**Correspondence given to the  
Design Commission on  
Monday, February 27, 2012**

**All Saints Church  
Master Development Plan  
Final Environmental Impact Report  
January 2012**

**RE: All Saints Church Master Development Plan**

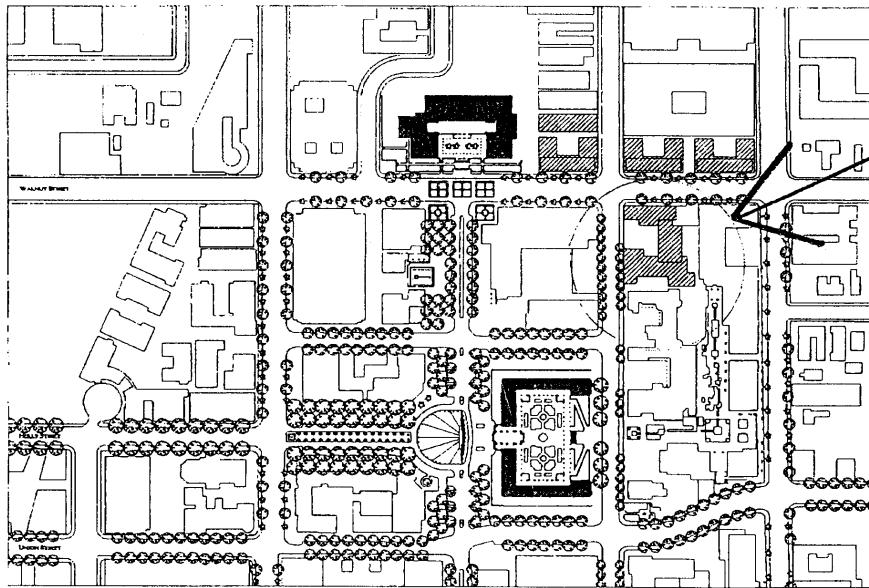
The proposed *Master Development Plan* should require that the new expansion project buildings fit in a harmonious way with the existing historically significant landmark setting and with the existing North Euclid Avenue street pattern that is characterized by interplay of green spaces and buildings. The Civic Center's foundational documents offer some *guidance* in developing Alternatives - the City Council-approved *Pasadena Civic Center Master Plan* (1990) ("Master Plan") [Lyndon/Buchanan Associates, consulting planners/architects] as reinforced by the City Council-approved *Civic Center/Mid-Town Programming Effort Report* (1998) (commonly known as the "Grey Report") [Moule and Polyzoides Architects and Urbanists, consultants]. Unlike the Specific Plan that addressed the Civic Center/Mid-Town area as a whole rather than on a block-by-block basis, both the Master Plan and the Grey Report focused on the Civic Center/Mid-Town area in

detail and on a block-by-block basis, including North Euclid Avenue. Although the Specific Plan states that these plans have been superseded, these prior City Council-approved planning documents are instructive and can be used to more accurately interpret and apply the Guideline statements contained in the Specific Plan. Importantly, they can be used to develop more robust Project Alternatives that more accurately reflect the intent of the Specific Plan

With respect to the site under consideration, the Master Plan required *courtyards* along North Euclid Avenue in order to reinforce the combination of "all of the elements of the Civic Center" and the existing green space/building footprint pattern along North Euclid Avenue as follows:

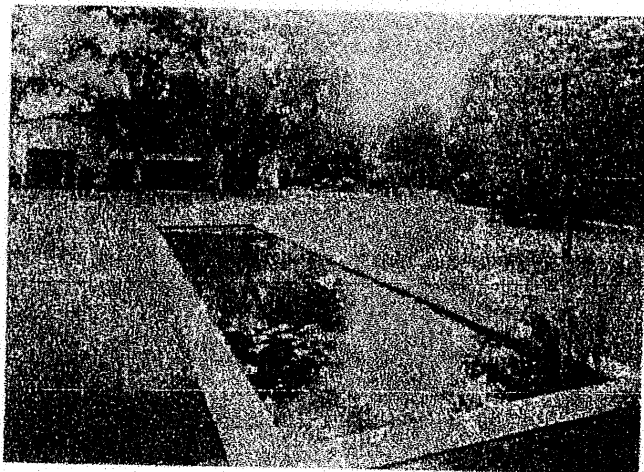
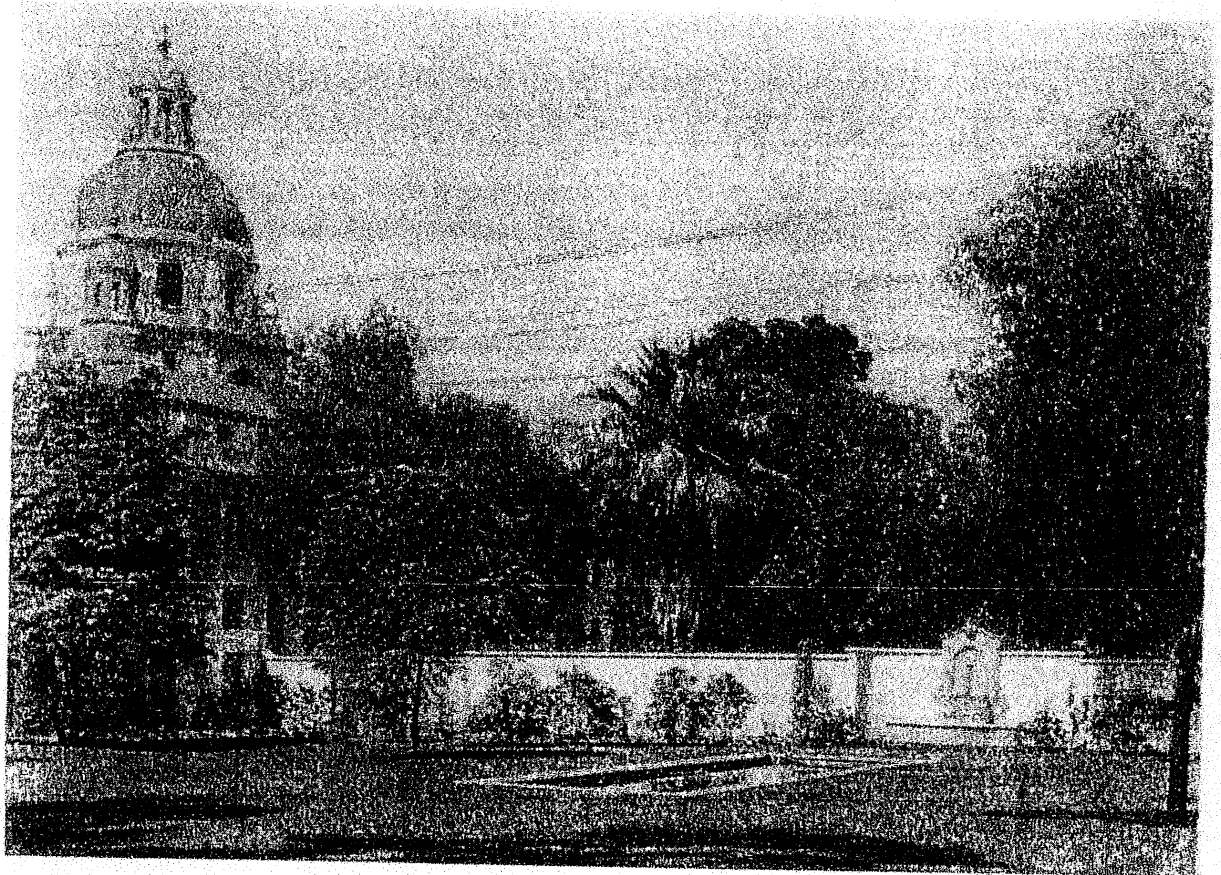
**Impact 3** (pp 12 ff). As has been argued elsewhere, the size, massing, proportions, bulk and scale of the proposed project are inconsistent with the size, massing, proportions, bulk and scale of buildings contributing to the District. The proposed building along Euclid is low in height, but with its long side parallel to the street and to the long building behind it, it is incompatible with the Euclid streetscape with features rectangular buildings (Maryland Hotel apts, All Saints Church, All Saints rectory), which are sited perpendicular to the street, not parallel, creating ample space for courtyards and open space. They do fill an existing void, but the site plan does not create the courtyards called for in the Gray Report or the Lyndon Buchanan Civic Center Master Plan. The effect is to close off the property to the public, both physically and visibly.

larger in scale. Showing that there are other buildings in the District of comparable or greater length than the proposed Building A ignores the specific context of the Euclid Avenue setting, which is discussed above. And to say that this project (i.e., any project on this site) is an improvement over the existing parking lot and small scattered buildings currently on the site is disingenuous at best. A poorly conceived project does not improve any site.

*The Spalding House yard and reflecting pool, adjacent to the Pasadena City Hall and the Maryland Hotel*

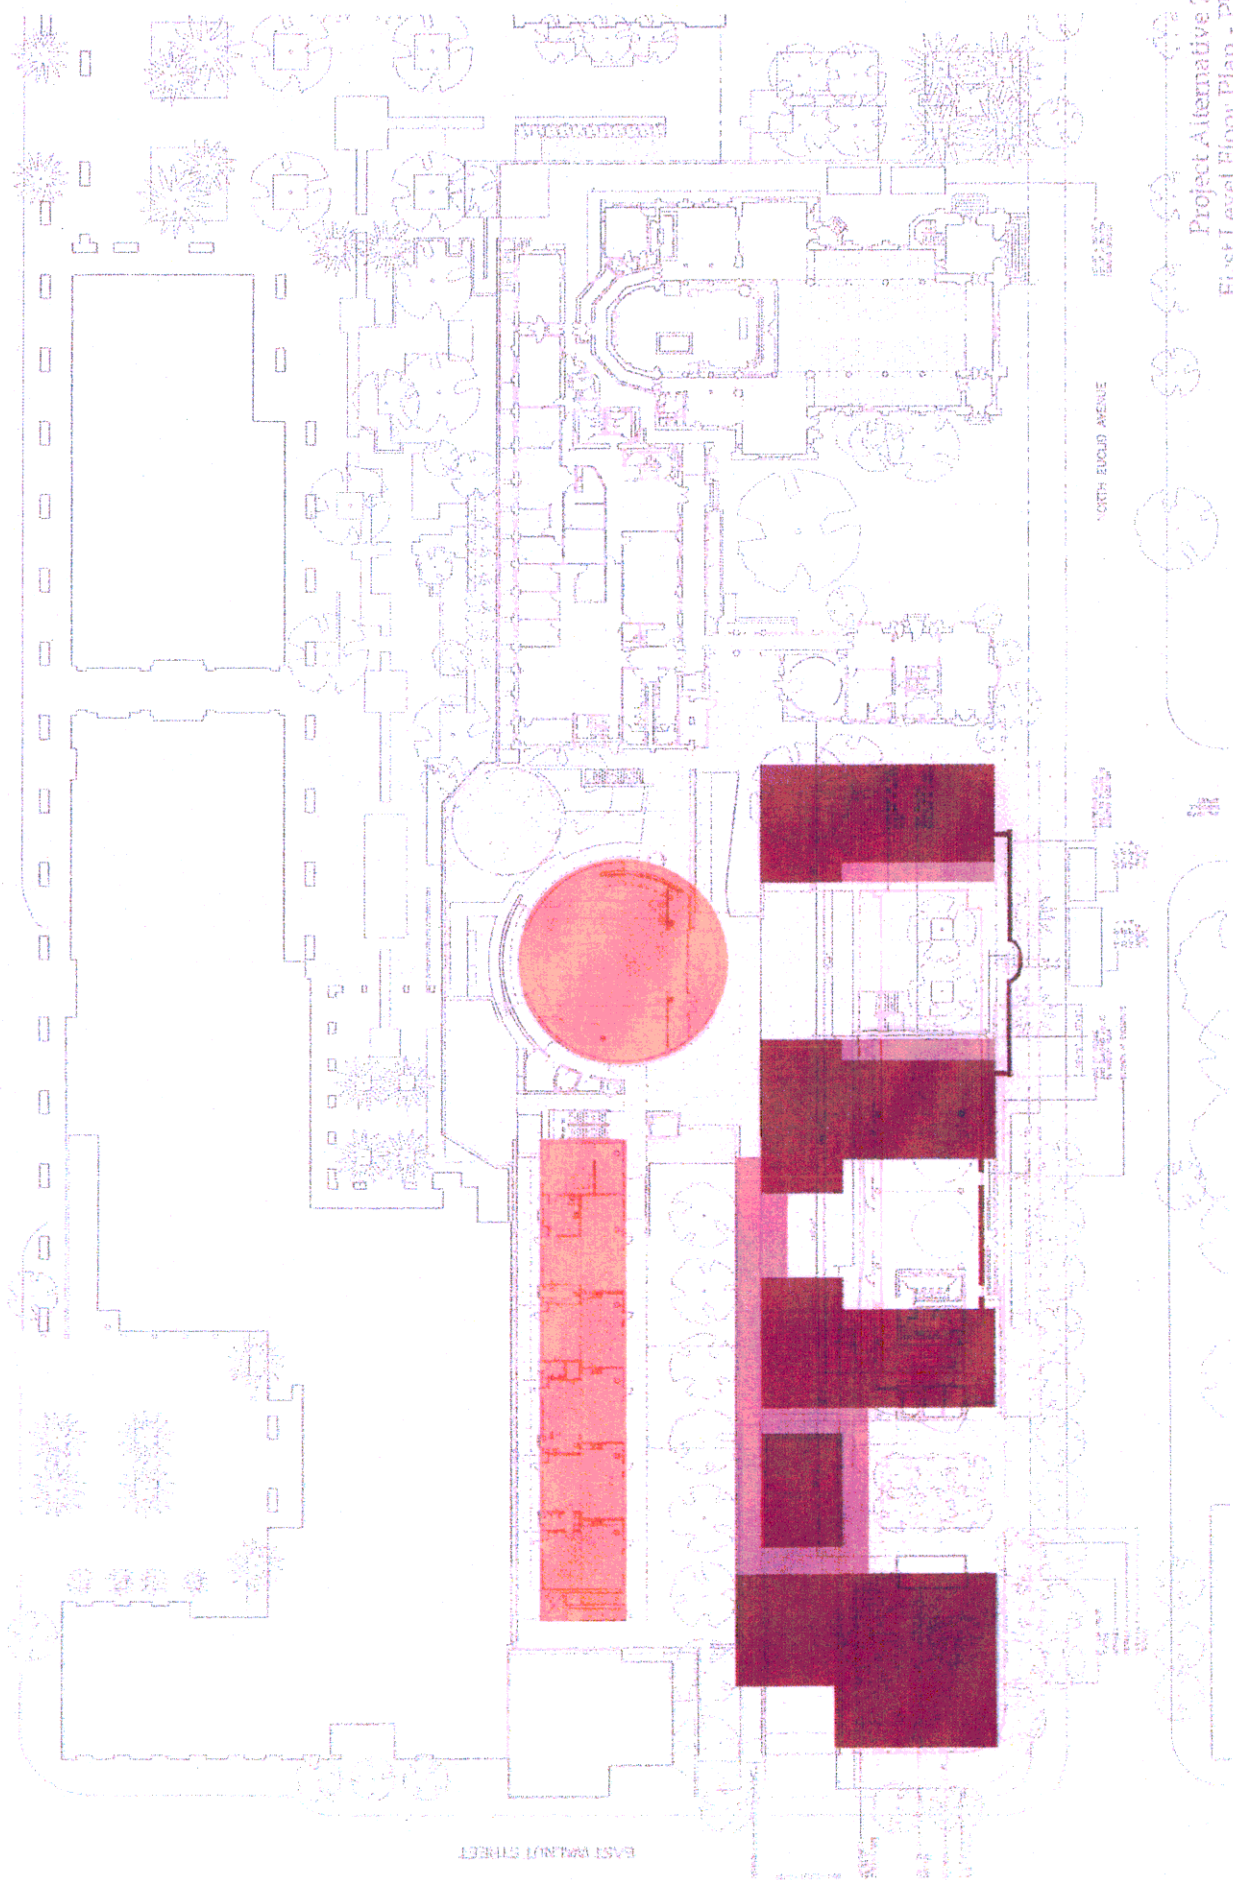
**The Maryland Hotel Wall:** The report omits information I provided to the City, at their request in May 2011. The wall served as the rear boundary of the garden of Keith and Eudora Spalding, who built a house designed by Wallace Neff on the Maryland Hotel grounds in 1926, concurrent with the construction of City Hall. The wall, also by Neff, is in the California Mediterranean style (not Georgian Revival as stated in the HRR). The Spaldings lived there until the Maryland closed (c 1934-35), when they moved to a bungalow at the Huntington Hotel where they lived under a similar arrangement on the hotel grounds. The attached photograph from Diane Kanner's book on Wallace Neff shows the garden and wall with City Hall in the background.

In the section **Project Impacts, Impact 2** (pp 11 ff). As is shown by the photograph of the Spalding/Neff wall (Maryland Wall) attached, that the area east of the wall was open space (a garden). Although that open space has been encroached on by a temporary trailer to the south and Scott Hall to the east, there is still considerable open space between the wall and Scott Hall. The Master Plan proposes the removal of both the trailer and Scott Hall. Relocating the wall is not consistent with the Guidelines.

Second Level Floor Plan  
Revised Massing Plan Option  
Date: 11/13/13  
Scale: 1/8" = 1'-0"  
29

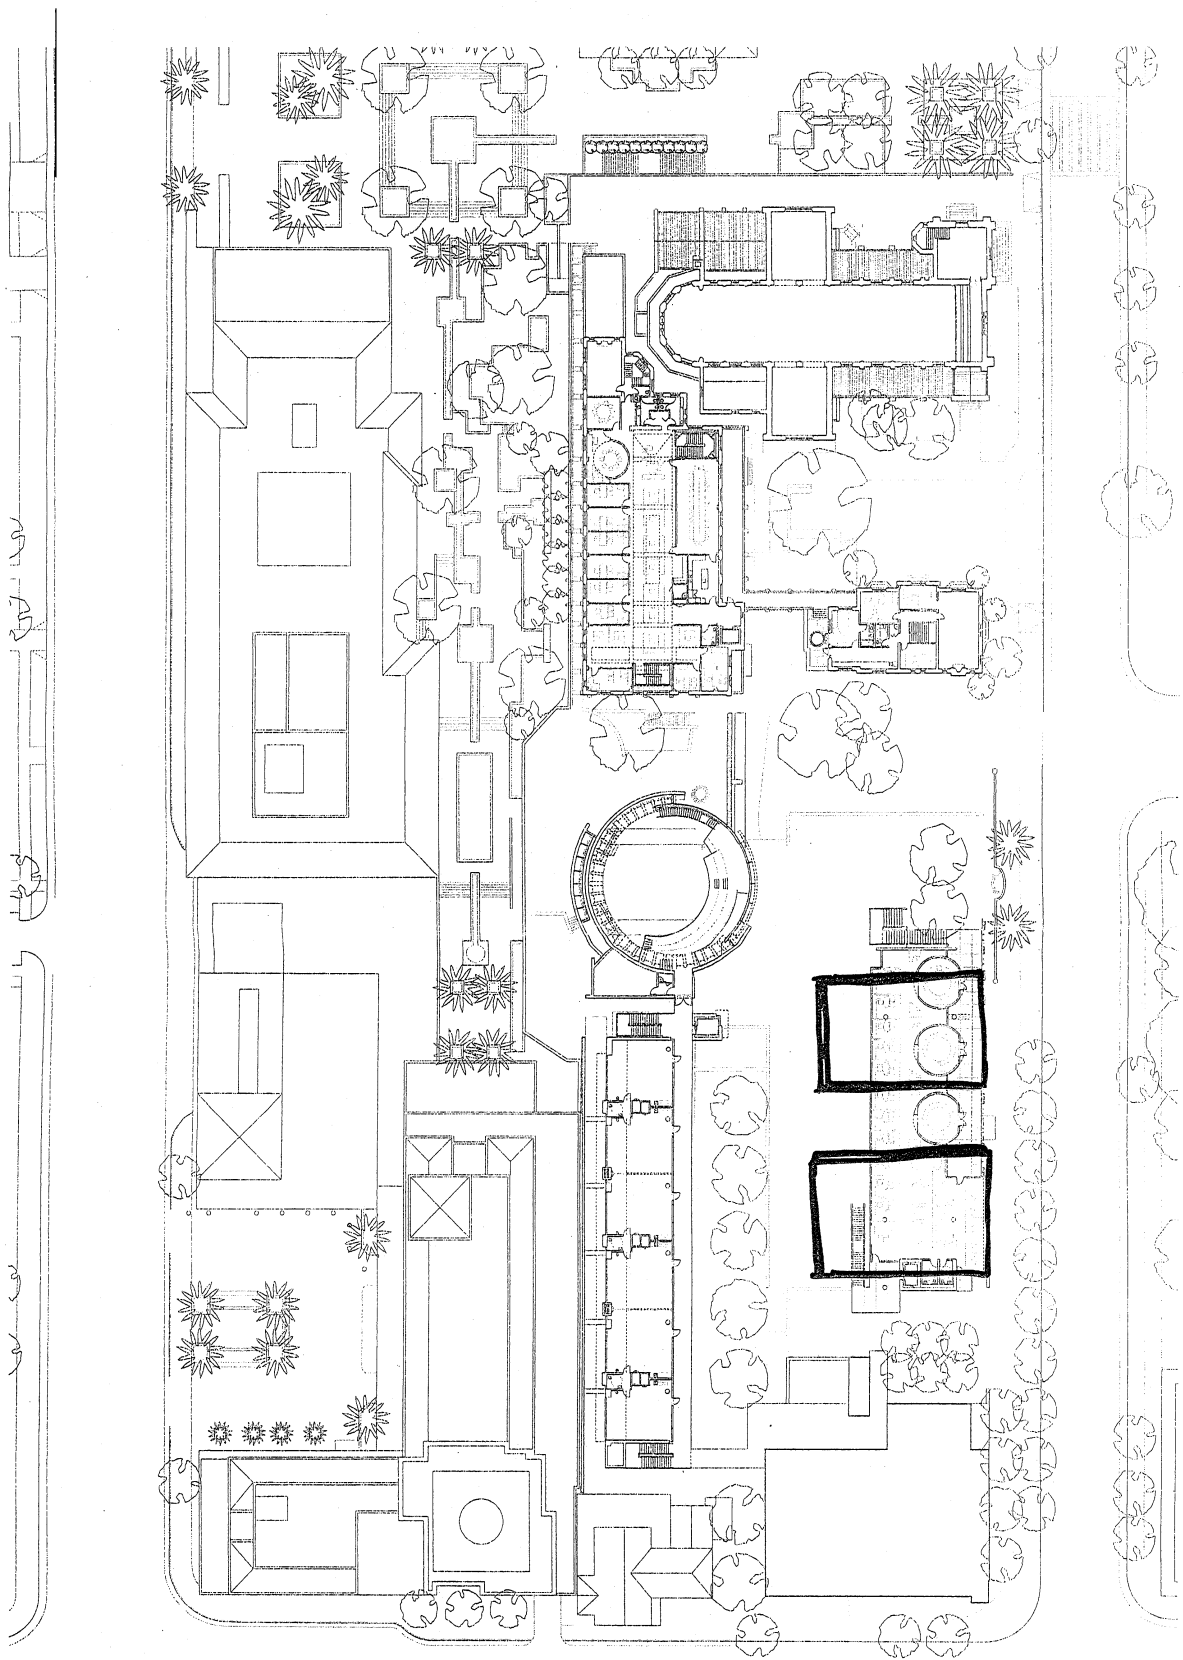
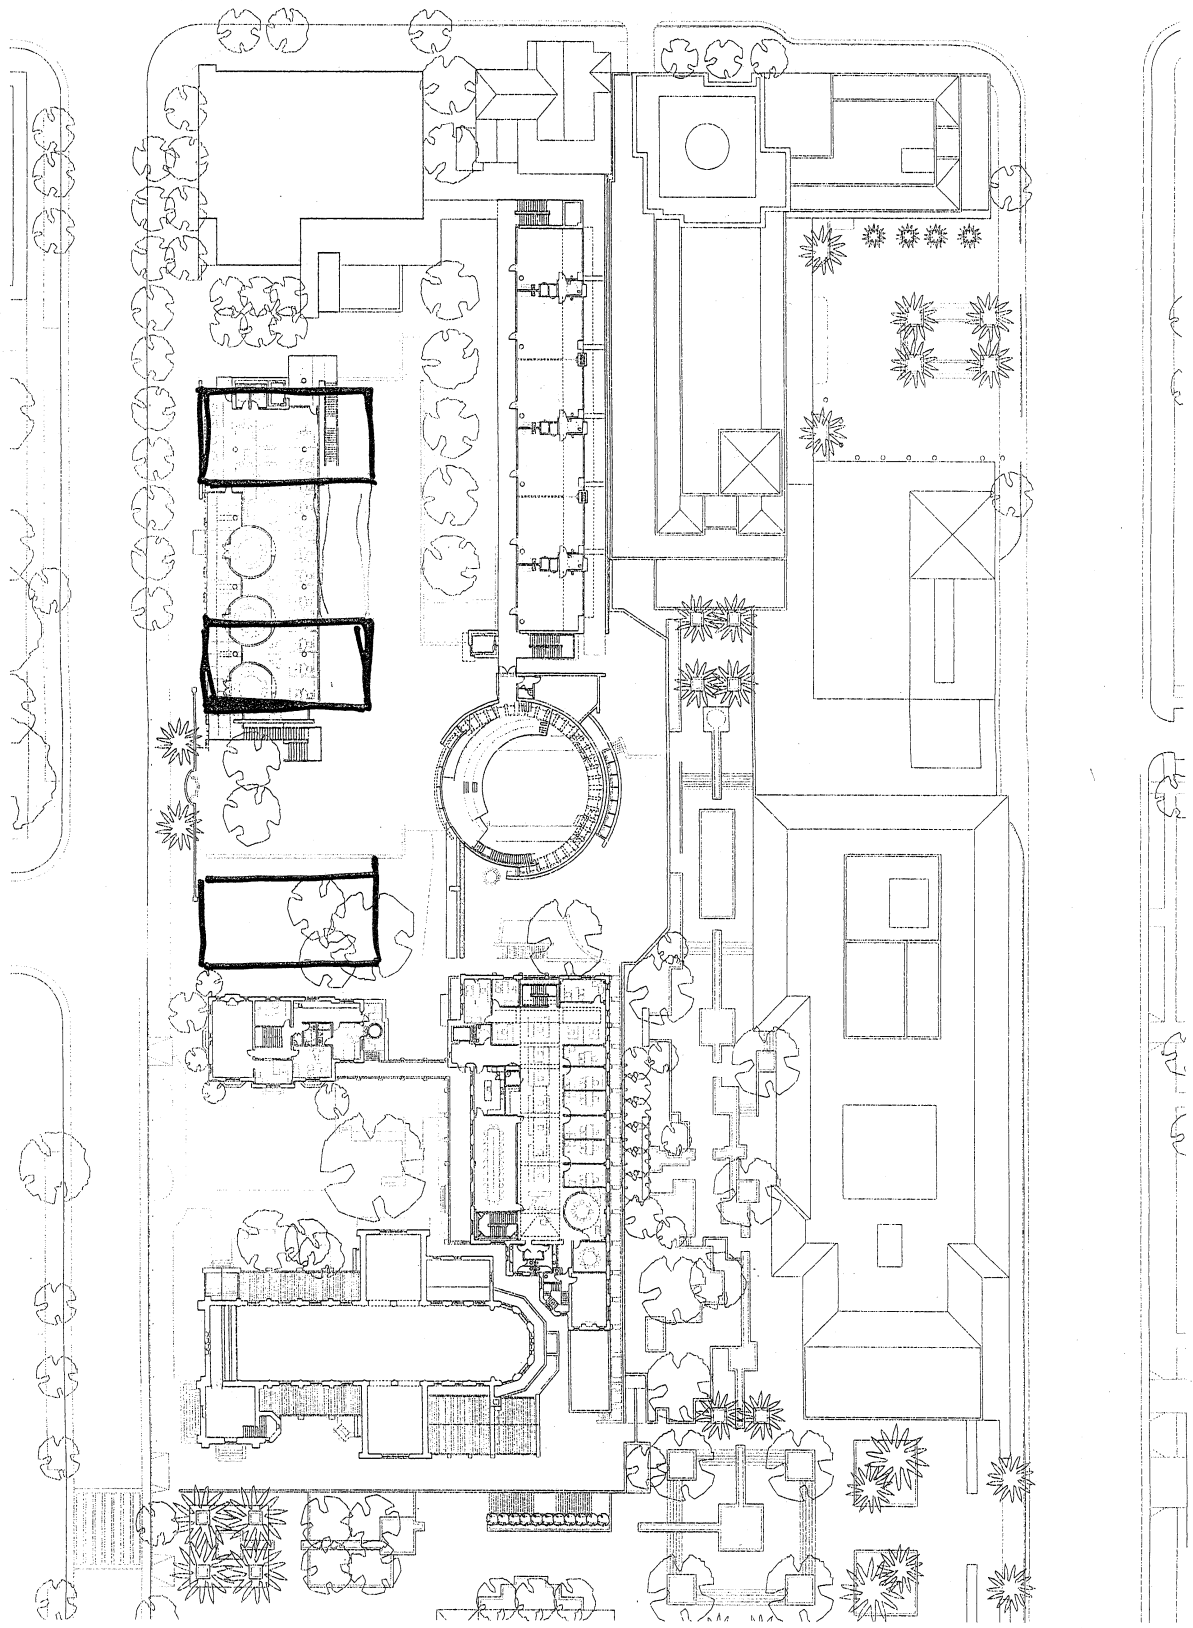
This is a finding – not a condition. It says that all this will happen, but can it happen given that the site plan is fixed upon approval?

**Add a Condition:**

The design of the new buildings must comply with the Secretary of the Interior's Standards and Guidelines and with the Central District Private Realm Design Guidelines and must be compatible with the adjacent historic buildings and the Civic Center Historic District. The Design Commission is responsible to determine conformance with the Standards and Guidelines and determine compatibility; therefore the Design Commission will have the discretion to require the alteration of building footprints or exact locations, if necessary, in order to achieve conformance and compatibility.
